**SECTION 4.55(1A) MODIFICATION APPLICATION – SSD 7388
31 WHEAT ROAD, SYDNEY (THE RIBBON) – MOD 14**

This Modification Application (MOD 14) has been prepared by Ethos Urban on behalf of Tianlong Ribbon Pty Ltd (Greateon), pursuant to section 4.55(1A) of the *Environmental Planning and Assessment Act 1979* (EP&A Act) to modify Development Consent SSD 7388 relating to 31 Wheat Road, Sydney (the site). The development is better known as The Ribbon.

Figure 2 Proposed ground floor layout

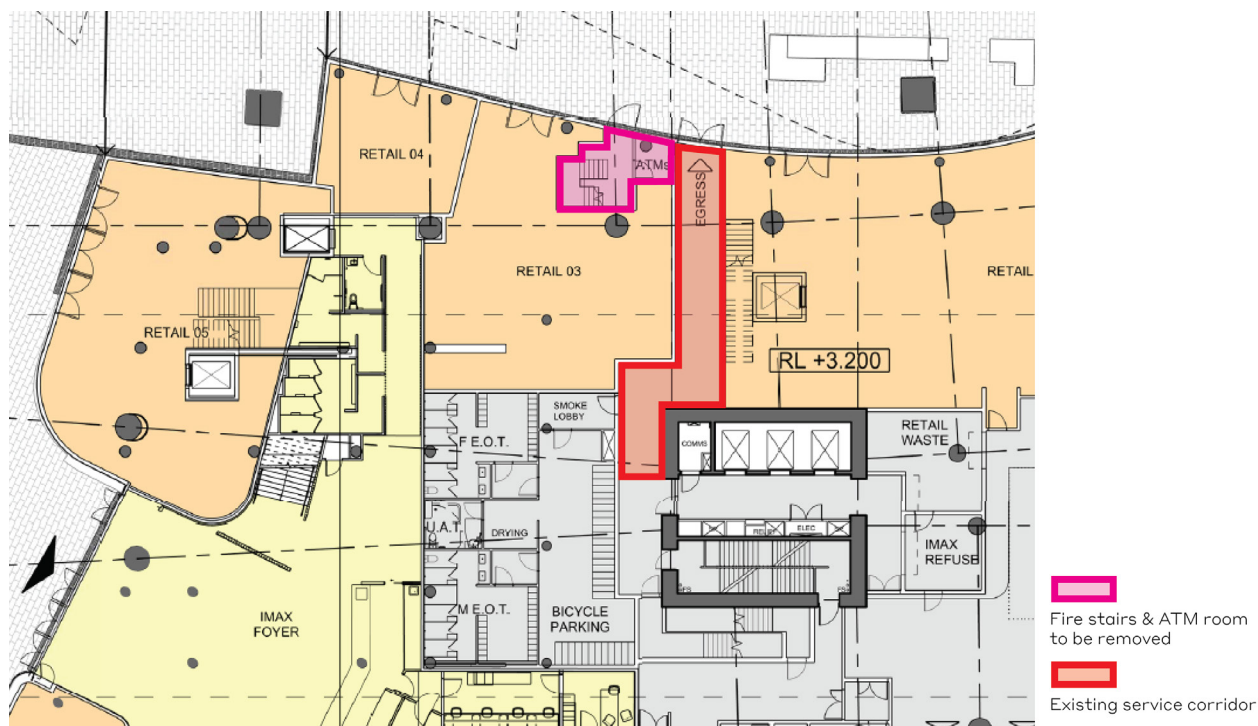
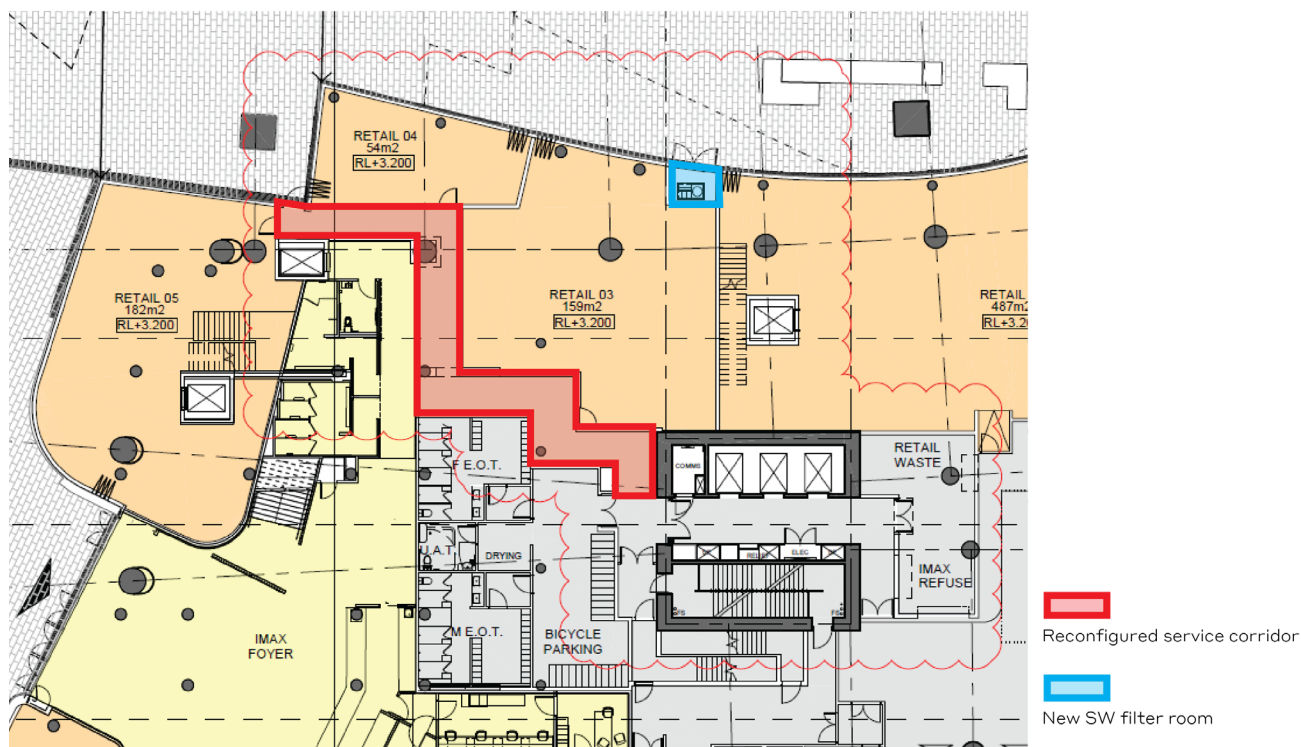
Fire stair R03 servicing Retail Tenancies 02 and 05 on Level 1 is proposed to be removed. Further review of the approved design has found the stairs and the ATM room to be redundant, providing an opportunity to increase GFA within two retail tenancies. A Fire Statement (**Attachment B**) has been prepared, confirming that the removal of the fire stairs will not implicate fire safety within the building.

The removal of the fire stairs and ATM room at ground level will increase floorspace to Retail Tenancy 03. The frontage of Retail Tenancy 03 has also been increased as a result of the change and will be replaced with additional operable glazing (refer to **Figures 1 – 2** below).

The approved back-of-house service corridor connecting the loading area and the building's northern façade is proposed to be reconfigured (refer **Figures 1 – 2**). The new arrangement will provide direct back-of-access to Retail Tenancies 04 and 05. Under the currently approved arrangement, retail personnel of these Tenancies have to exit the building and re-enter via the corridor's existing entrance on the northern façade.

As a result of the corridor reconfiguration, the installation of new double doors to the retail waste room and deletion of the smoke lobby and revised entry to the bicycle parking room are required. The proposed amendments are to enable delivery of large IMAX specialist equipment from the loading dock area to the IMAX theatre pit, located above the bicycle parking room. The reconfigured service corridor will not be able to facilitate this requirement.

A new stormwater filter room is proposed to be created in the space currently occupied by the existing back-of-house service entry (refer **Figures 1 – 2**). A detailed design review of the development has found this room to be necessary, with equipment in this room required to service the level 1 podium roof.

Figure 3 New Ausgrid staircase near southern site boundary (blue rectangle)

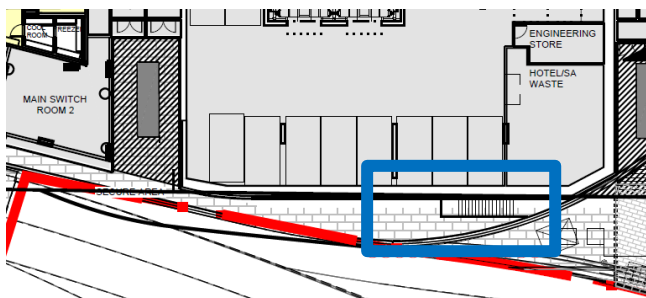
There is a requirement by Ausgrid in which 24/7 direct access is to be provided to access Vault O beneath the Western Distributor from the eastern side of the building. This has been proposed since there is limited space to access the Vault from the western side of the building as Ausgrid are required to transport materials and machinery into the vault at any given time. To comply with this requirement, a new external staircase is proposed at the site's southern boundary, as shown in **Attachment A** and **Figure 3** below.

Figure 5 Proposed level 1 layout

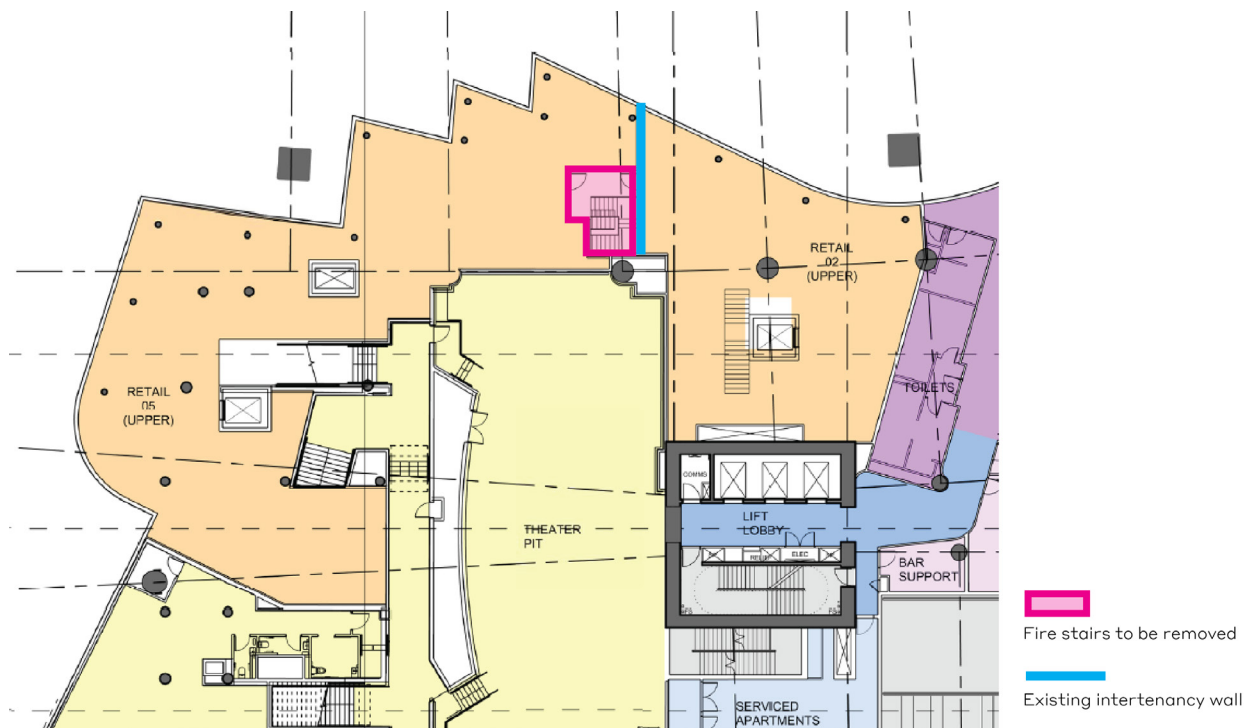
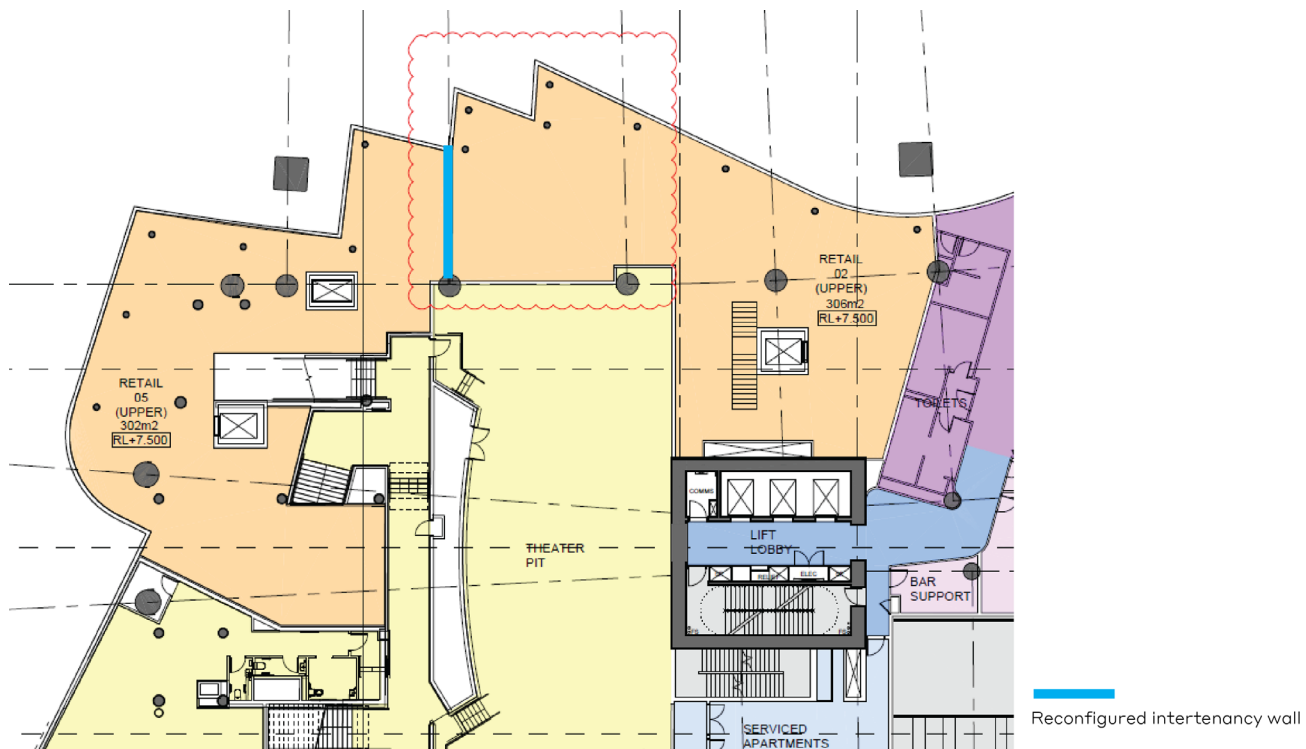
As aforementioned in **Section 2.1.1**, fire stair R03 is proposed to be removed. On the first floor, the removal of the fire stairs will increase floorspace to Retail Tenancy 02 (refer to **Figures 4 – 5** below). The Fire Statement (**Attachment B**) confirms that this removal will not implicate fire safety within the building.

The intertenancy wall between the Retail Tenancies 02 and 05 is proposed to be relocated, increasing the size of Retail 02, and decreasing the size of Retail 05. The relocation will improve and rationalise tenancy layout following the removal of the fire stairs (refer **Figures 4 – 5**). The Fire Statement (**Attachment B**) confirms this intertenancy wall adjustment will not implicate fire safety within the building.
